VIRGINIA ELECTRIC AND POWER COMPANY
RICHMOND, VIRGINIA 23261

VIRGINIA ELECTRIC AND POWER COMPANY
NORTH ANNA POWER STATION UNITS 1 AND 2
PROPOSED TECHNICAL SPECIFICATION CHANGES
REVISED CONTAINMENT ANALYSIS

Discussion of Changes

Figure 4.1
Containment Air Partial Pressure versus Service Water Temperature
(Revised Tech Spec Figure 3.6-1)

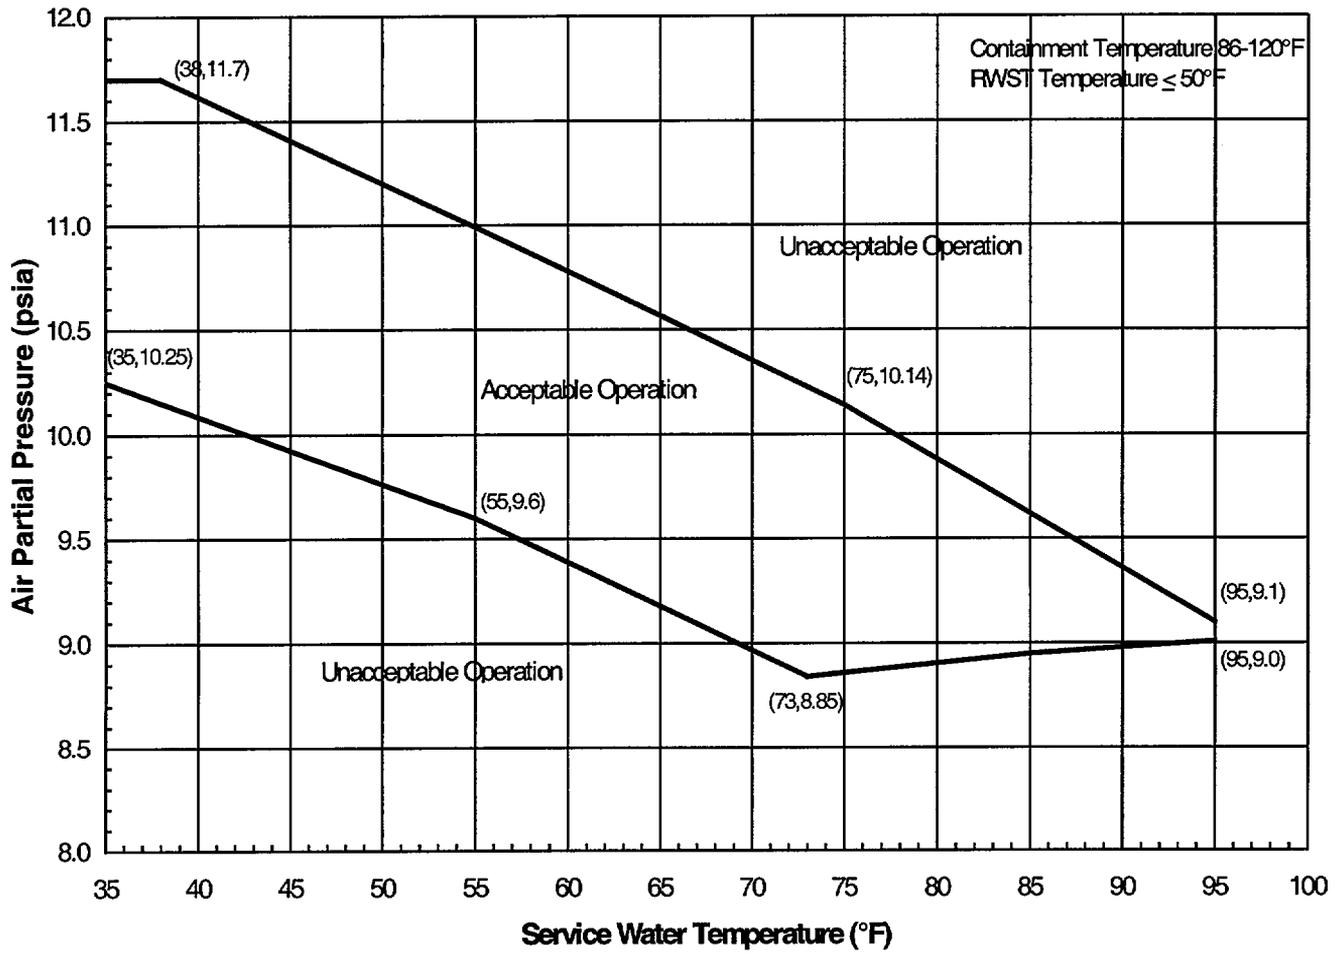
Technical Specifications Figure 3.6-1, "Containment Air Partial Pressure Versus Service Water Temperature" was revised as a result of the new containment analyses. The revised operating curve is provided as Figure 4.1. The peak pressure analysis sets the upper pressure limit below 38°F service water, the point where the peak pressure and depressurization analyses converge at 11.7 psia. The depressurization analyses create the upper pressure limit between 38°F and 95°F service water. The lower bound of the Technical Specifications containment air partial pressure operating curve is defined by the LHSI pump NPSH results for service water temperature greater than 73°F and by the RS pumps NPSH results for service water temperature less than 73°F. The containment air partial pressure is 8.85 psia for 73°F service water, where the curves intersect. This represents the minimum operating containment air partial pressure on Figure 4.1.

The revised containment analyses meet all of the acceptance criteria, as specified in the plant UFSAR, for operation in the allowable range of the revised Technical Specification containment air partial pressure operating curve. Specifically,

- The containment peak pressure is less than the 44.1 psig containment leakrate pressure limit (Technical Specification 3.6.1.2 and 3.6.1.3), and the peak temperature is less than the design limit of 280°F.
- The containment depressurizes to less than 14.7 psia in less than one hour and remains subatmospheric thereafter.
- The LHSI and RS pumps available NPSH is greater than the required NPSH during the postulated LOCA.

Figure 3.6-1 Containment Air Partial Pressure Versus Service Water Temperature

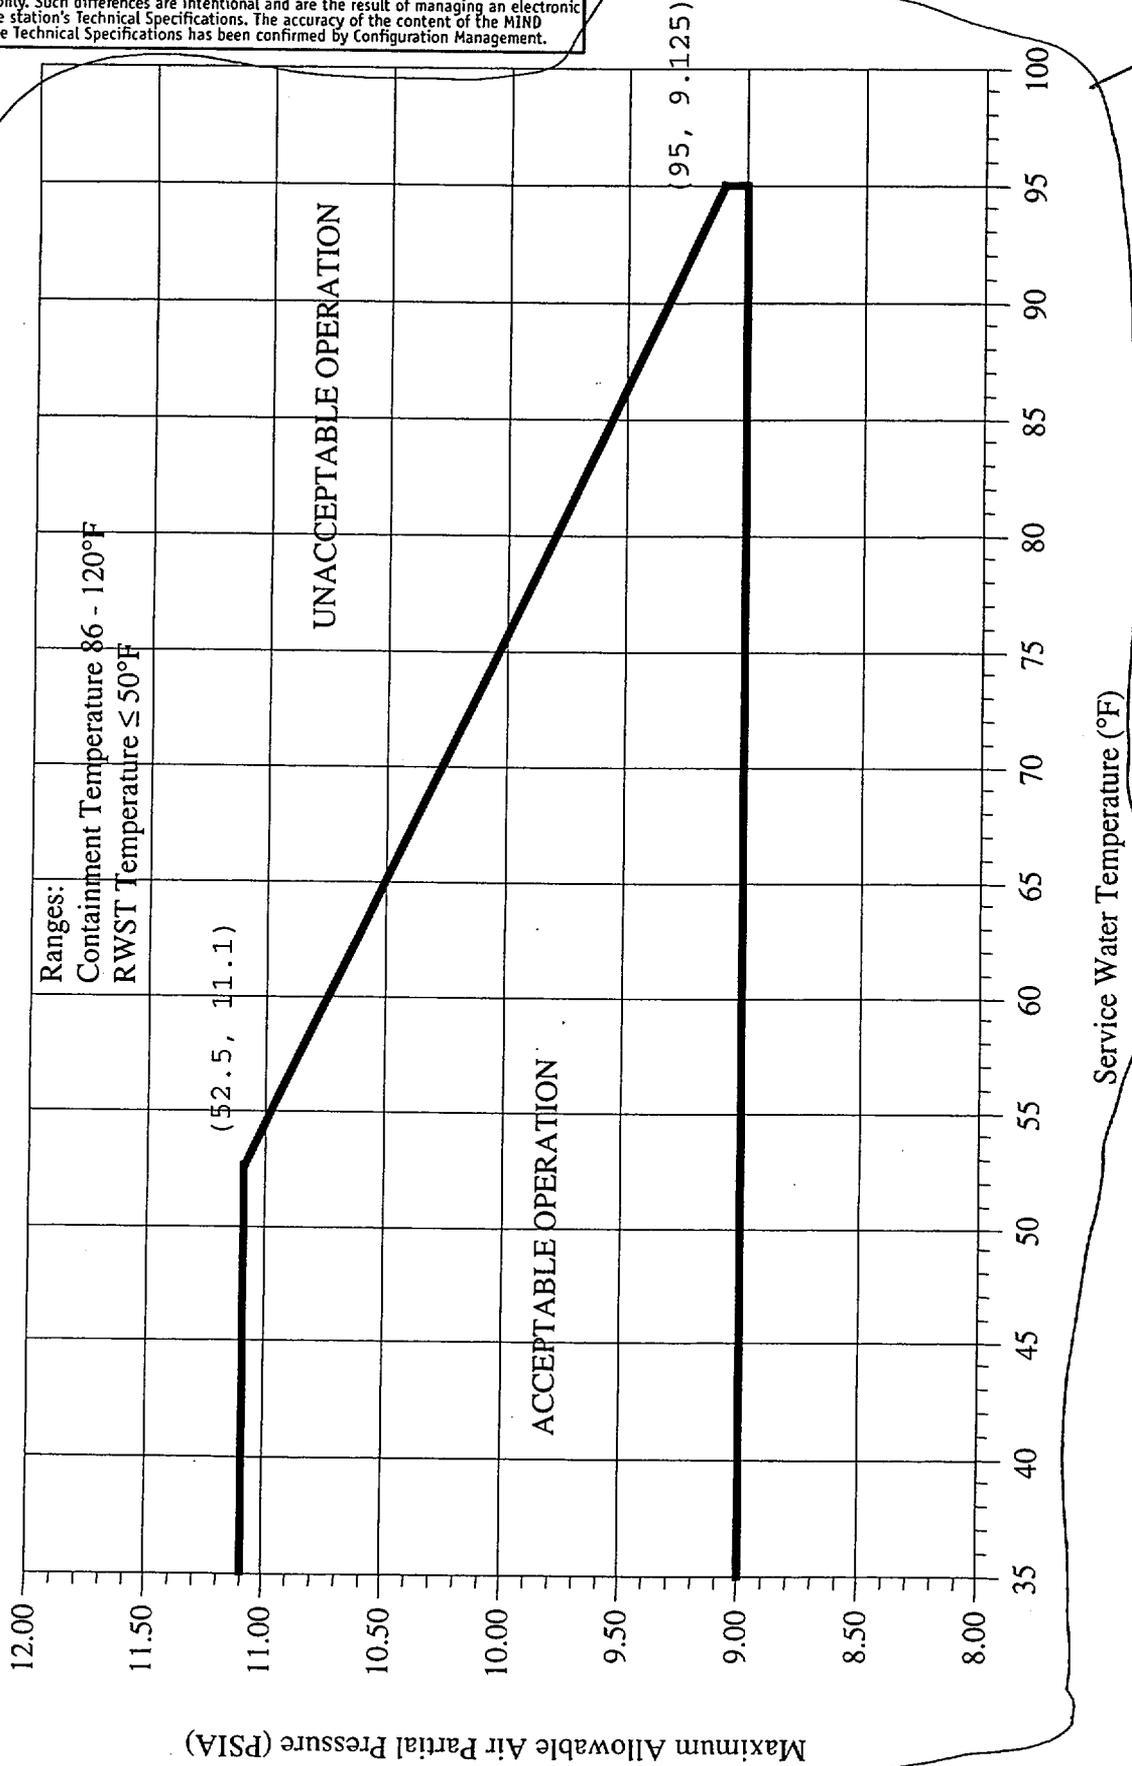
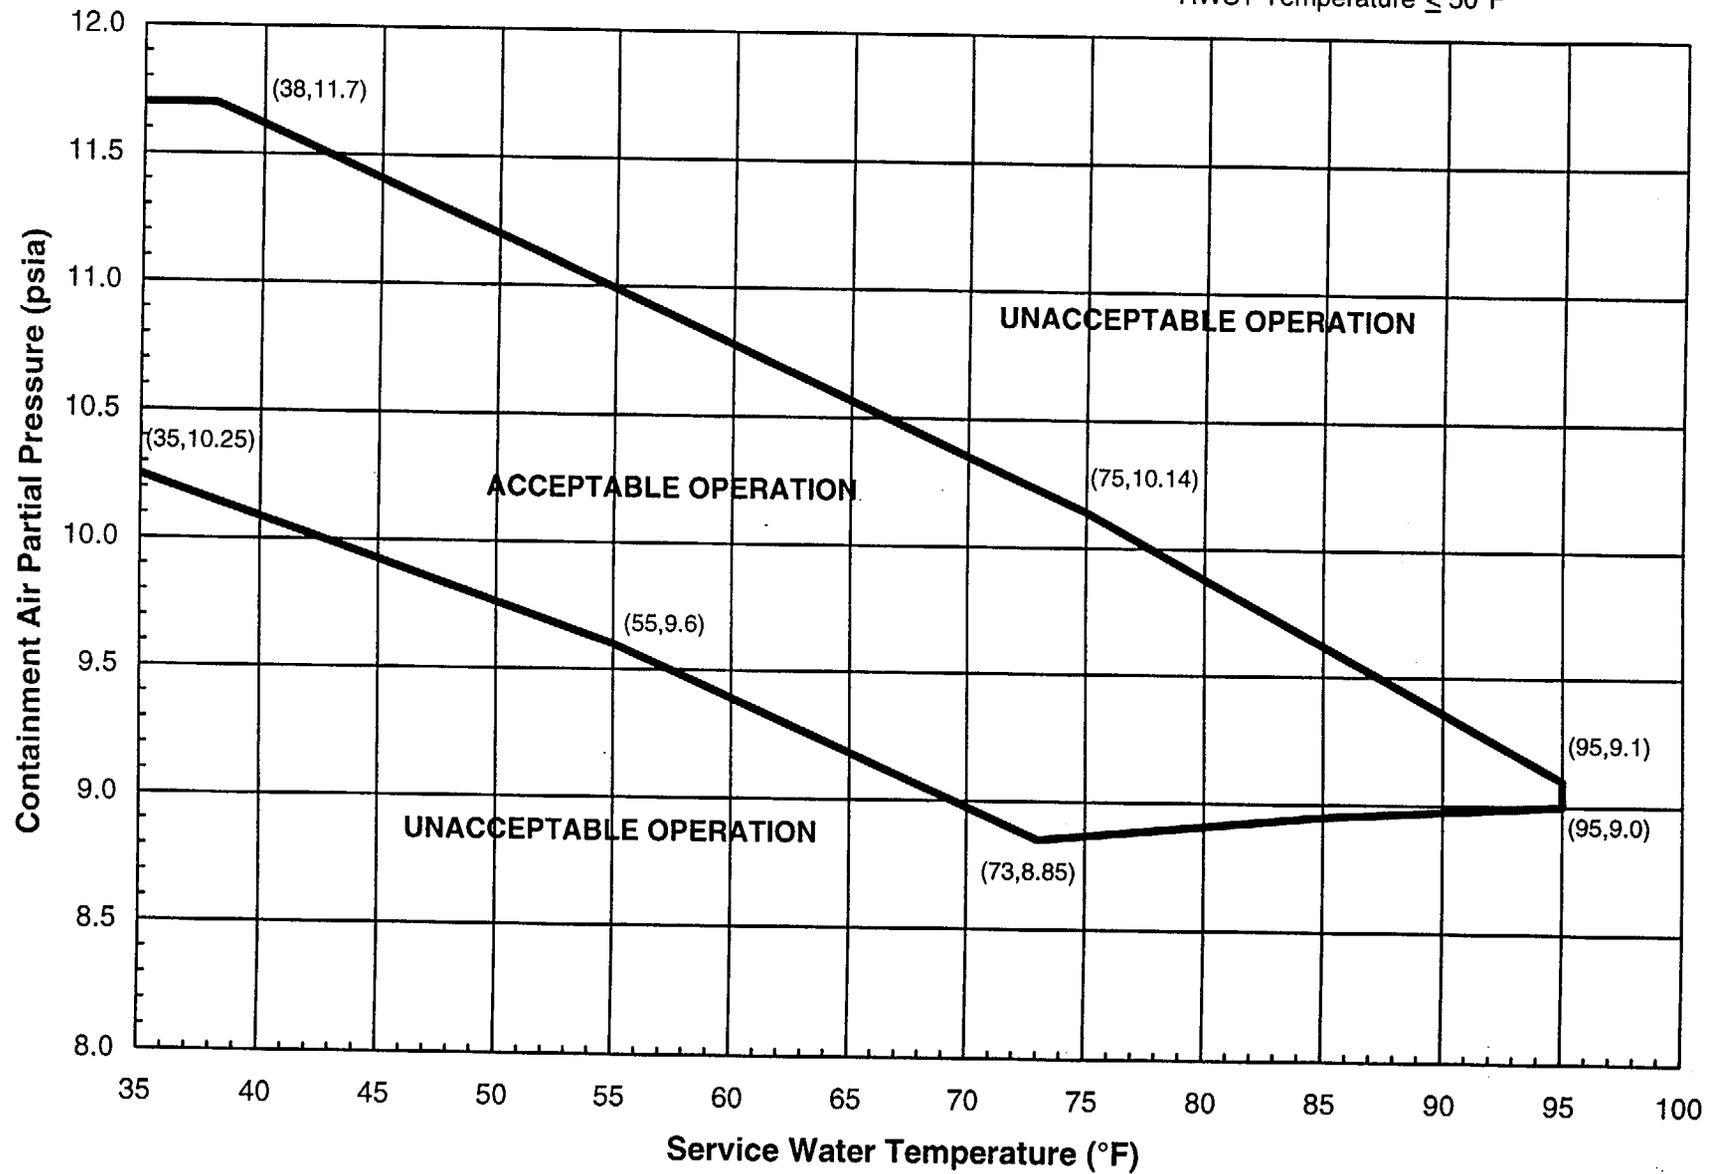
The specifications on the containment air partial pressure will be revised to the proposed operating curve in TS Figure 3.6-1, Containment Air Partial Pressure Versus Service Water Temperature. In addition, the text will be slightly modified to remove the reference to a constant air partial pressure lower limit of 9.0 psia, which is not a feature of the revised figure.

Replace with revise Figure 3.6-1

Figure 3.6-1: Containment Air Partial Pressure versus Service Water Temperature

Figure 3.6-1 Containment Air Partial Pressure Versus Service Water Temperature

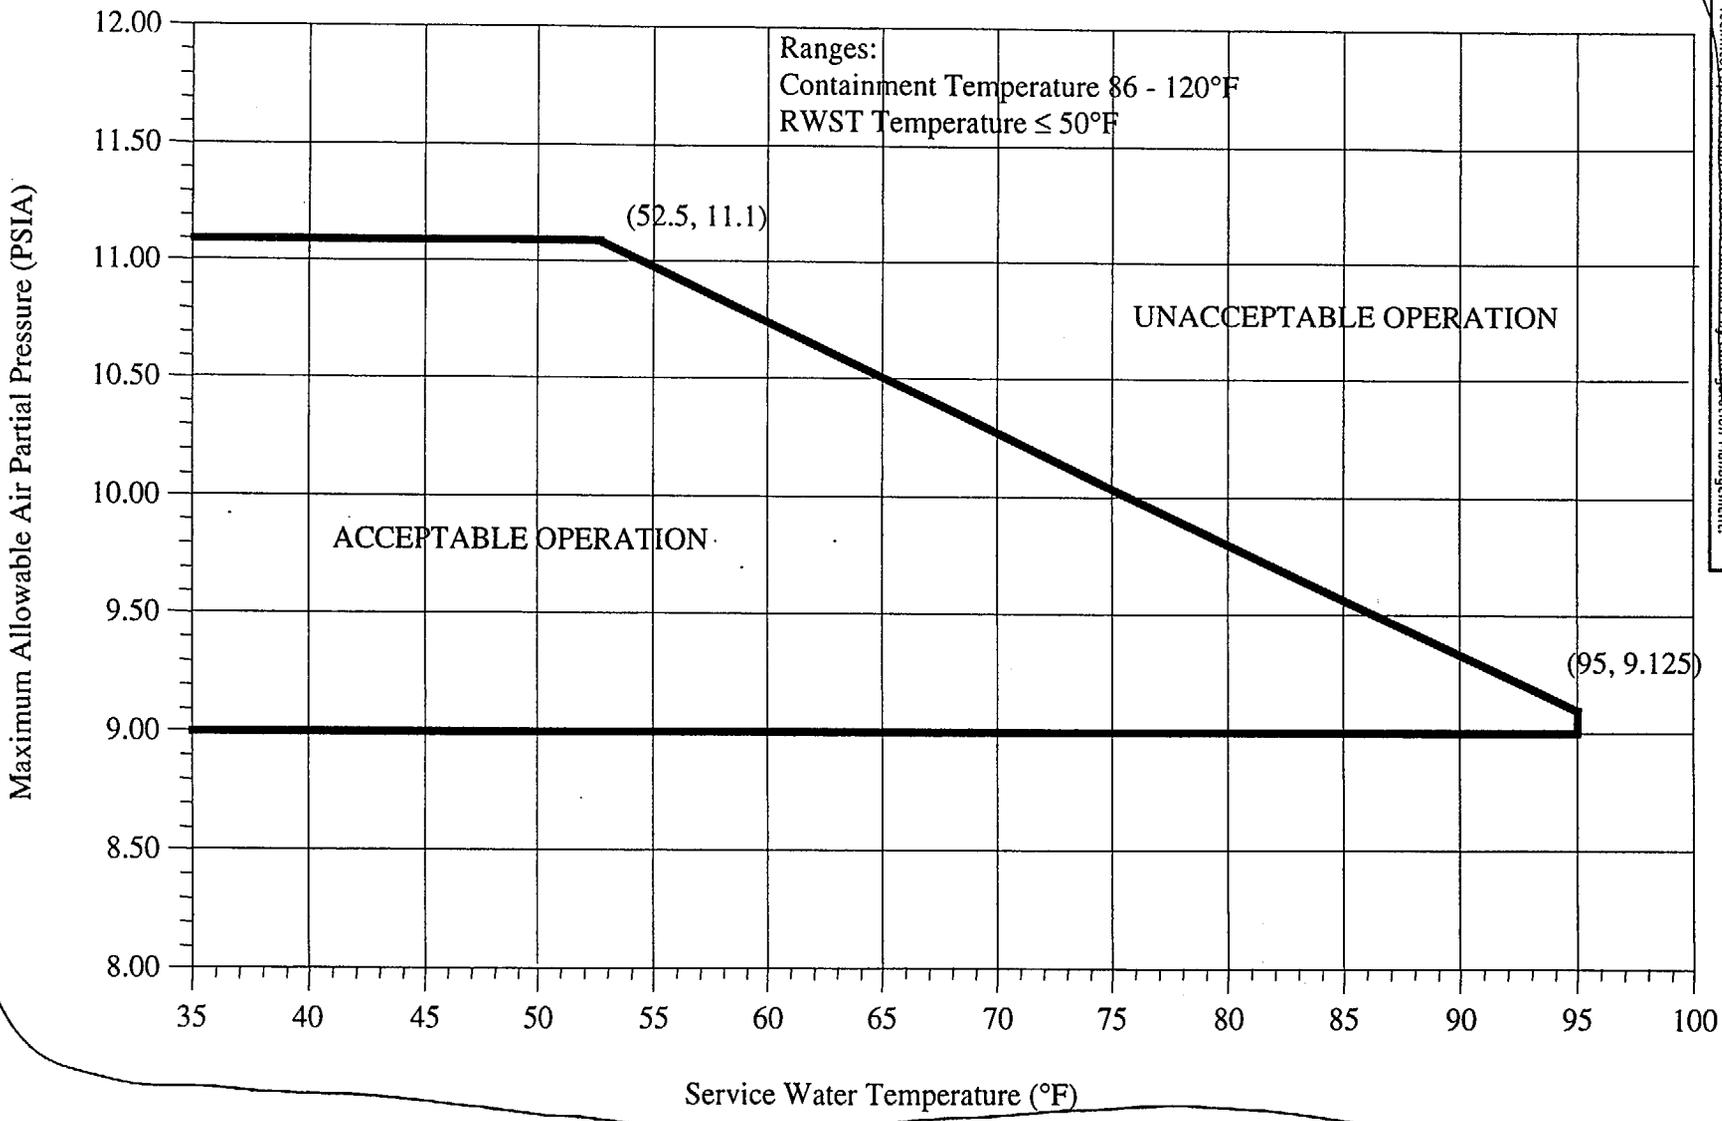
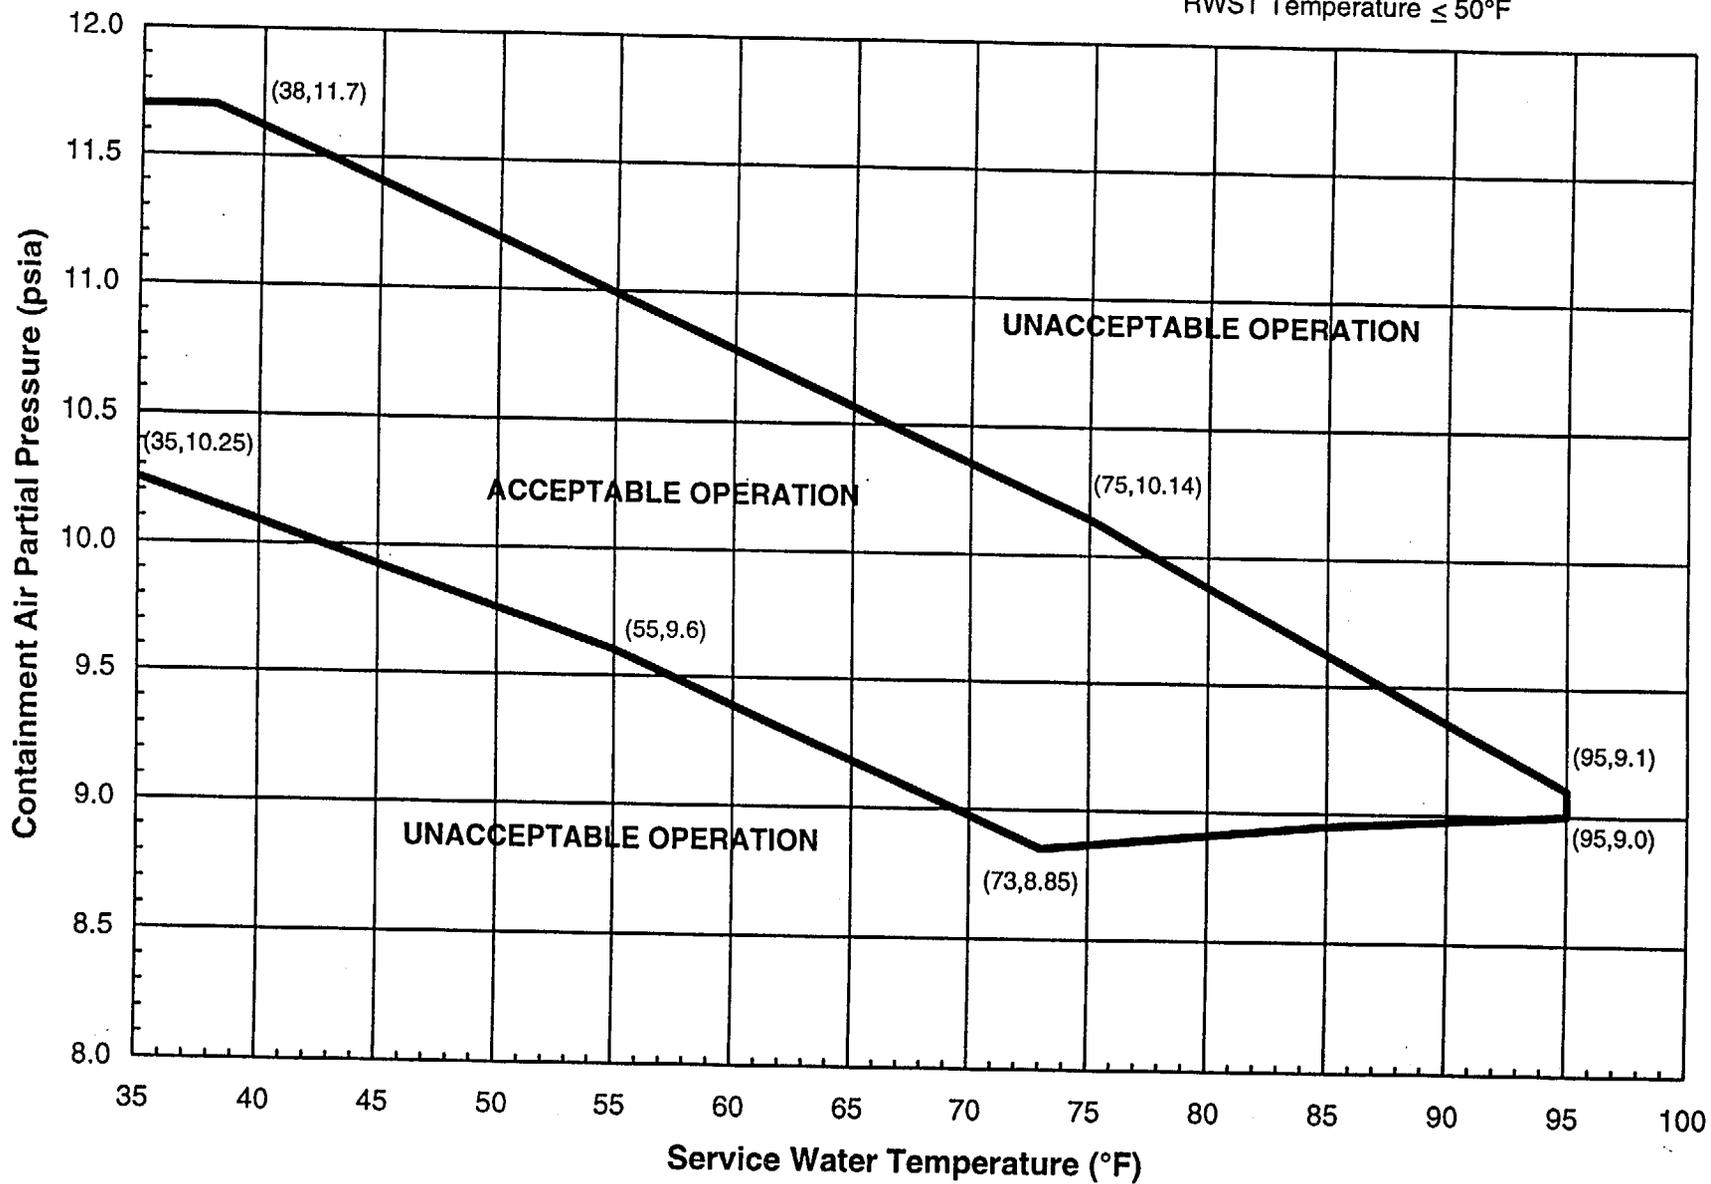
*Replace w
new figure
3.6-1*

Figure 3.6-1: Containment Air Partial Pressure versus Service Water Temperature

Figure 3.6.4-1 (page 1 of 1)
Containment Air Partial Pressure Versus
Service Water Temperature

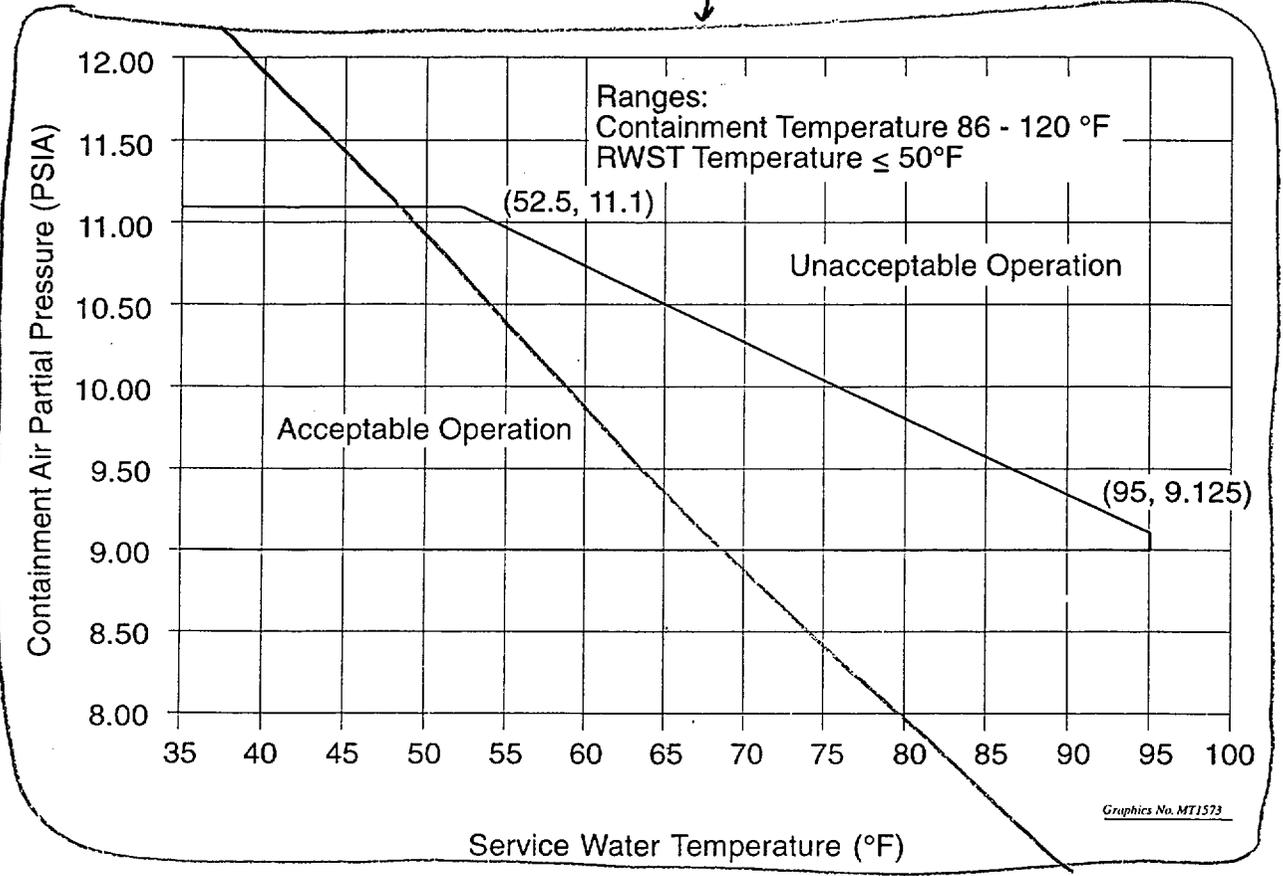
The containment air partial pressure versus service water temperature operating curve in Figure 3.6.4-1 will be changed to the new curve. In addition, the text will be slightly modified to remove the reference to a constant air partial pressure lower limit of 9.0 psia, which is not a feature of the revised figure. The Bases to ITS 3.6.4 will be updated with applicable analysis inputs and results. These changes are consistent with the proposed CTS changes described in Section 3.1.1.

Replace with
new Figure
3.6.4-1
